Addendum No. 1

Owner: City of Unalaska

Project: **2020 PARK AND PLAYGROUND IMPROVEMENTS**
DPW Project Nos. 19102, 15202

Date: December 2, 2019

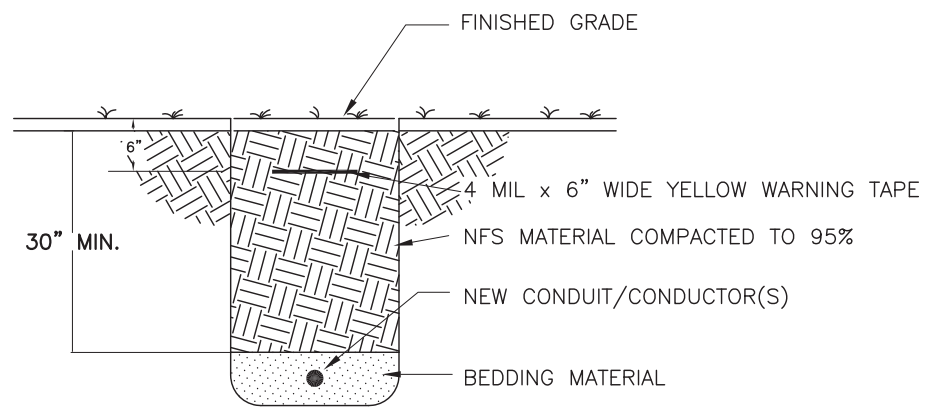
Item 2.1: PLAN SET, *Replace Plan Sheet No. 6 of 30, UCSD PARK DEVELOPMENT & LAYOUT PLAN* with the attached revised sheet. Three light poles, a load center and and electrical conduit/conductors were added to the development plan.

TITLE: UCSD PARK
ADD. ALT 2 - LIGHT POLES

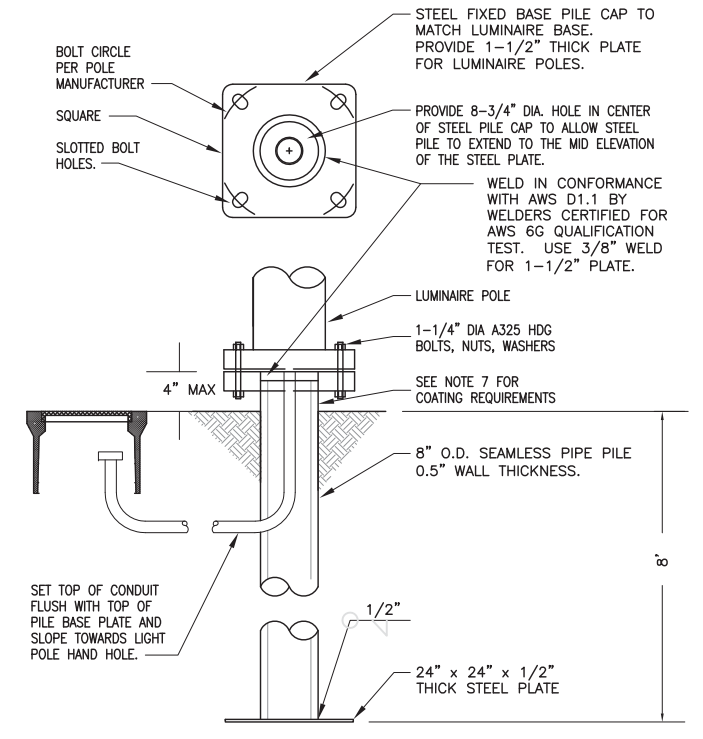
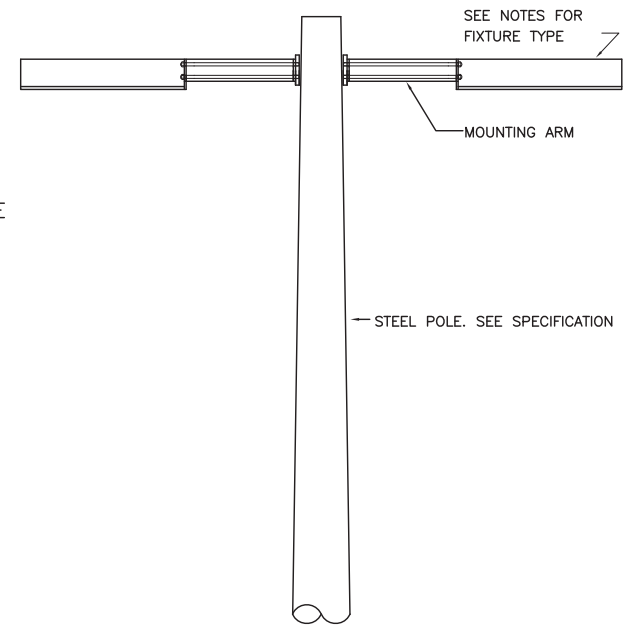
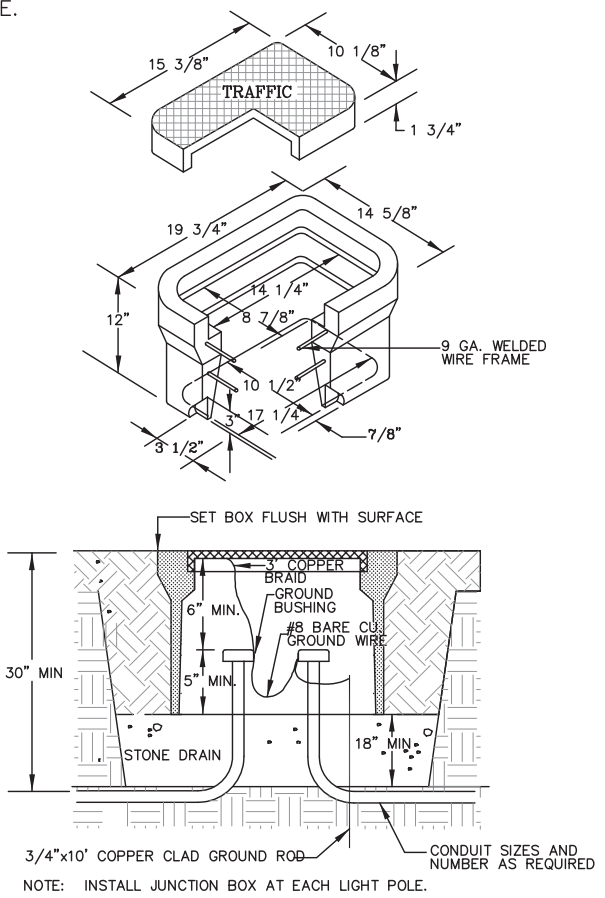
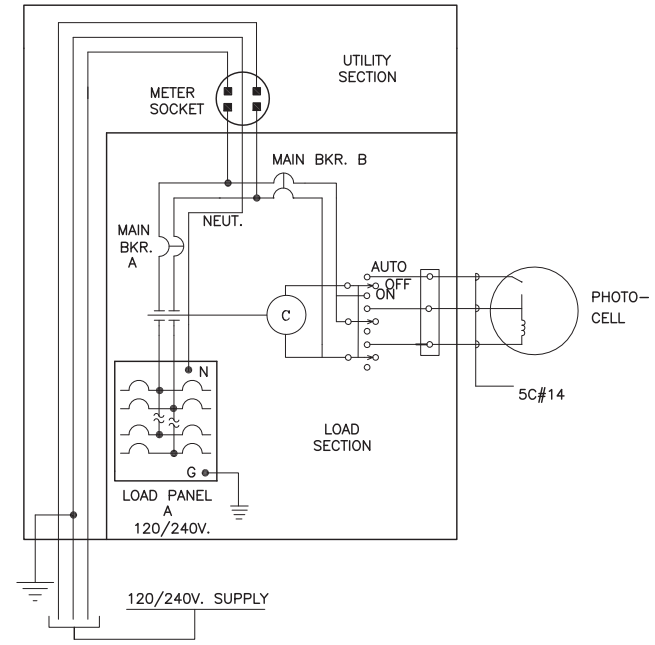
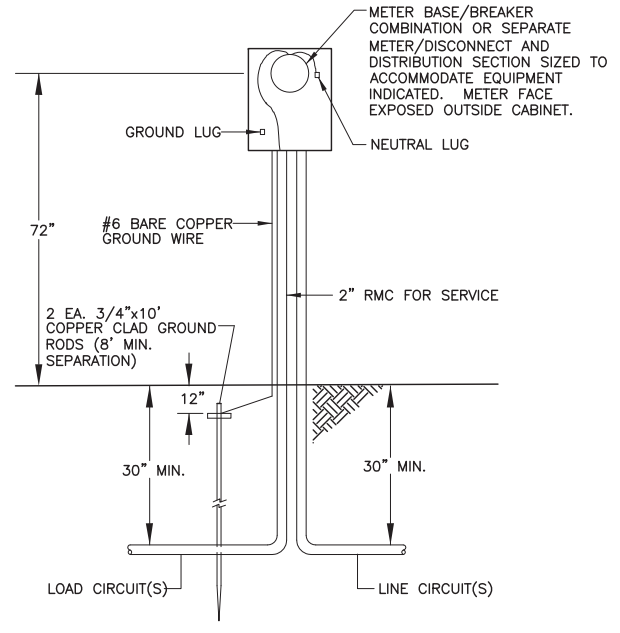
Item 2.2: PLAN SET, *Add Plan Sheet No. 15.1 of 31, UCSD PARK ADD. ALT 2 – LIGHT POLES*. The added sheet is attached to this addendum. The sheet provides details for the light poles and associated electrical work.
